Work Order ID 134870

Item Name: Quick Release Basket and Long Cargo Tube Mounting Provisions, Fits LH or RH

DART SERVICE INSTRUCTION

TO AMEND INSTALLATION INSTRUCTIONS D350-607-3 Rev.D,
INSTALLATION INSTRUCTIONS D350-607-4 Rev. C AND
INSTRUCTIONS FOR CONTINUED AIRWORTHINESS ICA-D350-607 REV. 6
REF TCCA STC: SH94-14
REF FAA STC: SR00213NY
REF EASA STC: EASA.10016996
REF BRAZILIAN STC: 2007S03-03/-04/-05/-06

FIGURE 1: INSTALLATION OF D4775-041 FWD STRUT

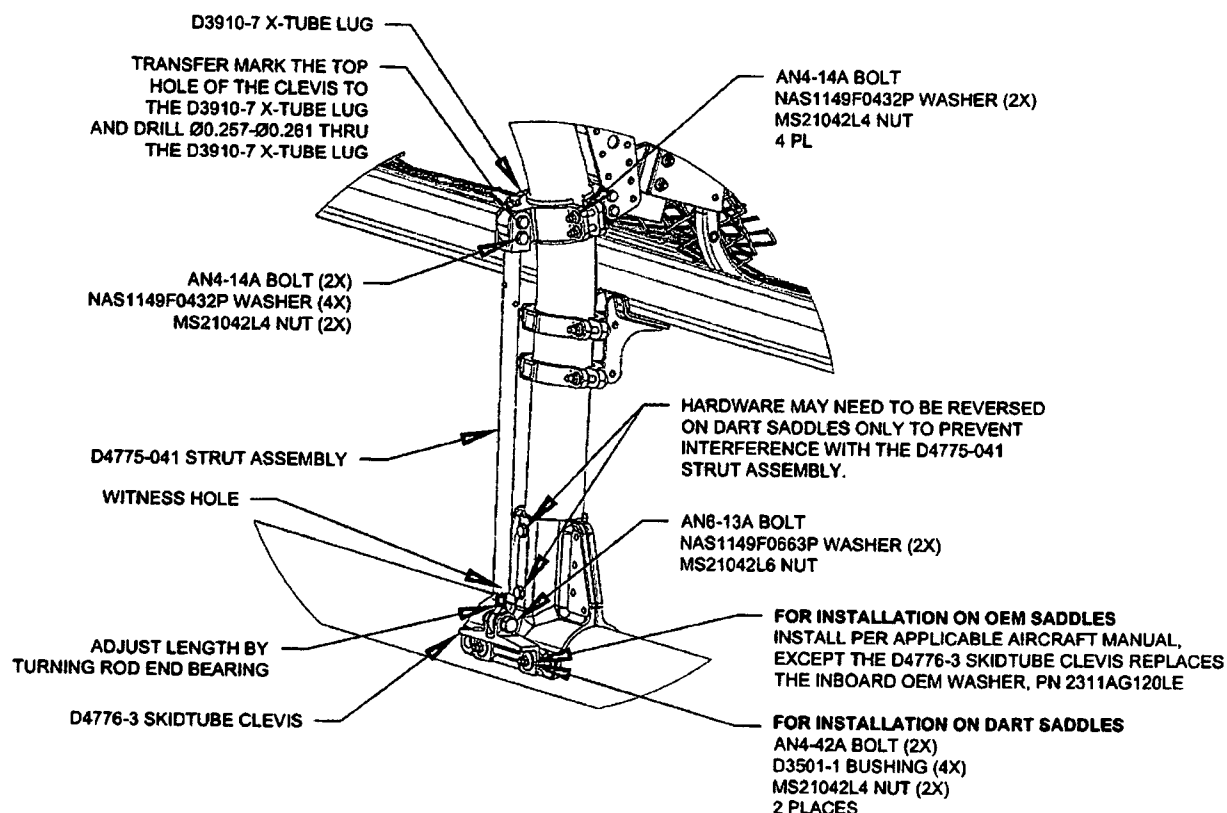
- 3.1 Substitute the Forward Lower D3910-5 X-Tube Lug with the D3910-7 X-Tube Lug as shown in Figure 1.
- 3.2 Install the forward D4775-041 Strut Assembly. Transfer mark from the upper hole on the clevis of the D4775-041 Strut Assembly to the D3910-7 X-tube Lug and drill thru the lug $\varnothing 0.257$ - $\varnothing 0.261$ as shown in Figure 1. Touch up chemical conversion coating per MIL-DTL-5541. Check the witness holes located at the bottom end of the D4775-041 Strut Assemblies to ensure that the thread from the rod end extends past the witness hole. **Torque MS21042L4/-4 nuts to 50-70 in-lbs (5.7-7.9 N-m). Torque MS21042L6/-6 nuts to 160-190 in-lbs (18.1-21.5 N-m).**
- 3.3 Complete the installation in accordance with Installation Instructions D350-607-3 Rev. D or D350-607-4 Rev. C.
